# UNITED STATES PATENT AND TRADEMARK OFFICE

APPLICATION NO.	FILING DATE	FIRST NAMED INVENTOR	ATTORNEY DOCKET NO.	CONFIRMATION NO.
09/954,806	09/18/2001	Hiroyuki Akashi	09792909-5185	8207

<b>Office Action Summary</b>	<b>Application No.</b>	<b>Applicant(s)</b>	
	09/954,806	AKASHI ET AL.	
	<b>Examiner</b>	<b>Art Unit</b>	
	Raymond Alejandro	1745

## **DETAILED ACTION**

Figure 4 shows the thickness of a positive electrode active material layer wherein P represents the electrode layer (section 0119).

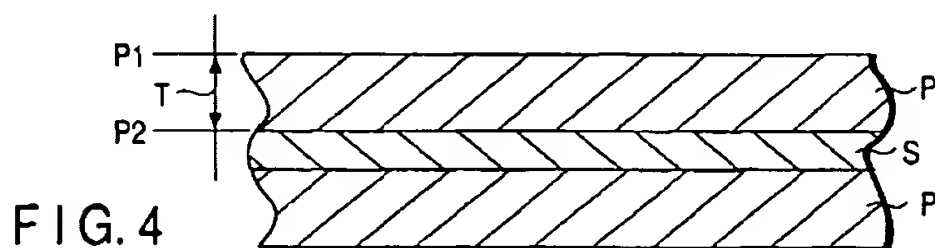
The EP'960 reference teaches that the thickness of the positive electrode layer should be 10-100  $\mu\text{m}$ ; it follows that where positive electrode layers are formed on both surfaces of the collector, one positive electrode layer has a thickness of 10-100  $\mu\text{m}$ , naturally, the total thickness of the two positive electrode layers formed on both surfaces of the collector is 20-200  $\mu\text{m}$ . It is also disclosed that **the upper limit in the thickness is preferably 85  $\mu\text{m}$**  (section 0119/ 0158)

*(← **emphasis added**). Hence, the EP'960 reference envisions the claimed thickness, at least, from 80 to 100 Tm when one layer is formed, and at least, from 80 to 200  $\mu\text{m}$  when two layers are formed thereon.*
